GFA AIRWORTHINESS DIRECTIVE

- TYPE AFFECTED:** AMT 200 Super Ximango Serial Numbers 200.040, 200.045 to 200.070.
- SUBJECT:** Exhaust pipe movement.
- BACKGROUND:** A downwards movement of the exhaust pipes and the muffler caused by engine vibration is possible. As this displacement reduces the ventilation space between muffler and the inside of the lower engine cowling the lower engine cowling may be damaged.

SERVICE BULLETIN

Title: EXHAUST SYSTEM - MODIFICATION OF EXHAUST PIPE CLAMPS.

Figure #1

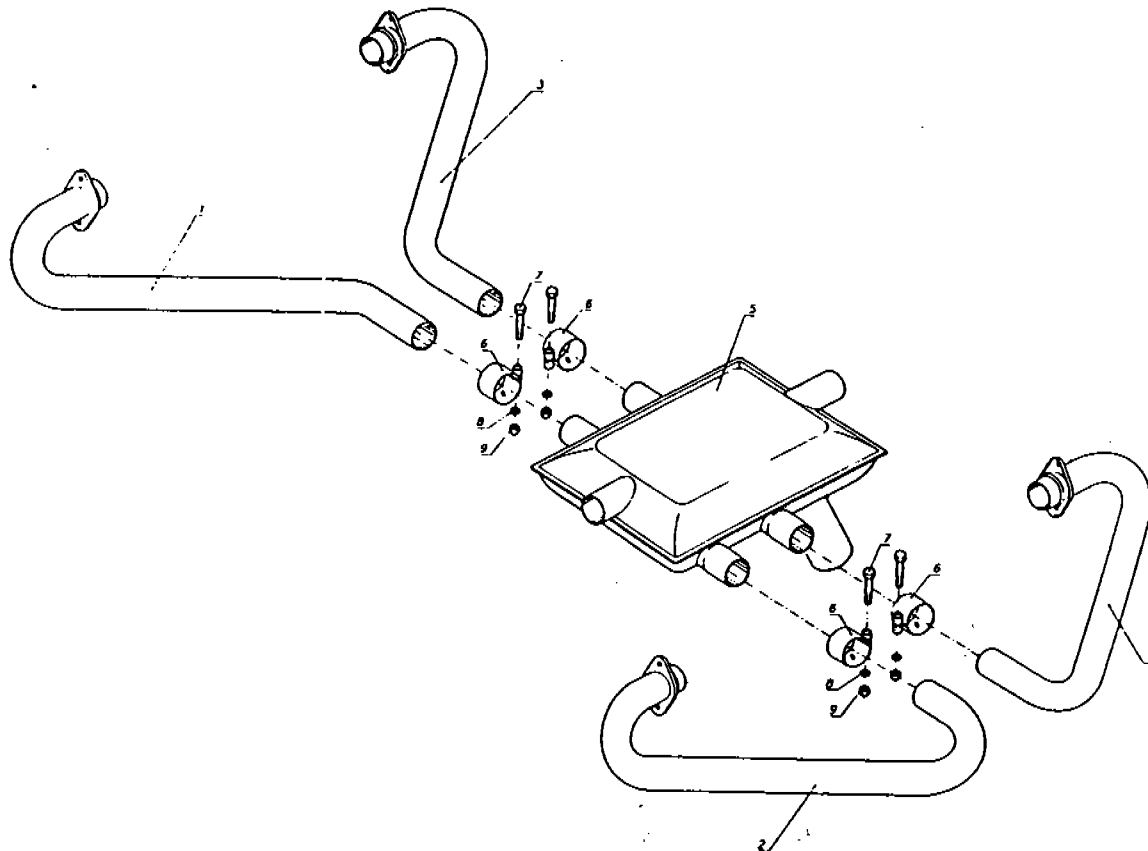
2.1.2 Loosen the four screws P/N AN 5C 11A (see item 7 figure #1) and move the muffler P/N 61624 (see item 5 figure #1) up until the distance between deflector sheet P/N 61629 (screwed to engine mounts) and muffler is about 10 mm.

2.1.4 Drill each clamp P/N 61625/1 (see item 6 figure #1) together with exhaust tube P/N 61632, 61633, 61634 and 61635 (see items 1, 2, 3 and 4 figure #1) with a drill Ø 3,2 mm (Ø 1/8"). See these procedures in the figure #2.

1. Drill the clamps P/N 61625/1 (see item 6 figure #1) **already mounted** together with the exhaust tubes (see items 1, 2, 3 and 4 figure #1).
2. Drill only one side of the clamps and exhaust tubes; it is not a passing bore.
3. If any clamp present some problem, substitute for a new one.

Figure #2

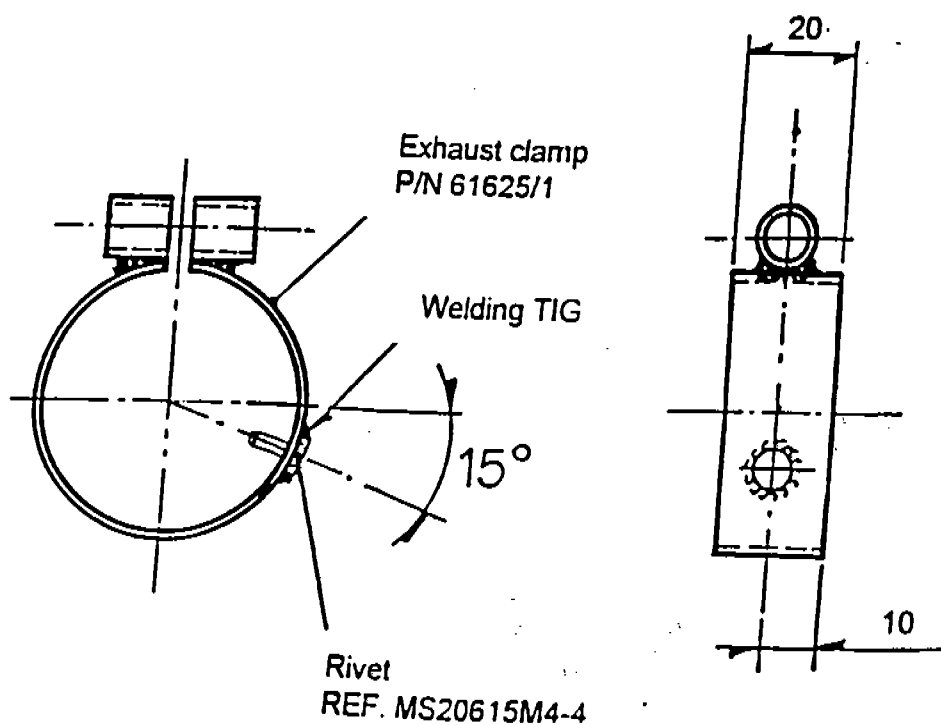
- 2.1.5 Introduce a stainless steel rivet REF. MS20615 M4-4 in drilled bore of the exhaust clamp exhaust tube and weld it (TIG) onto the clamp P/N 61625.1 (see figure #2).
- 2.1.6 Mount engine lower cowl and check if the exhaust tubes P/N 61632, 61633, 61634 and 61635 and muffler P/N 61624 do not touch the inside of the cowl.
- 2.1.7 Mount engine upper cowl.
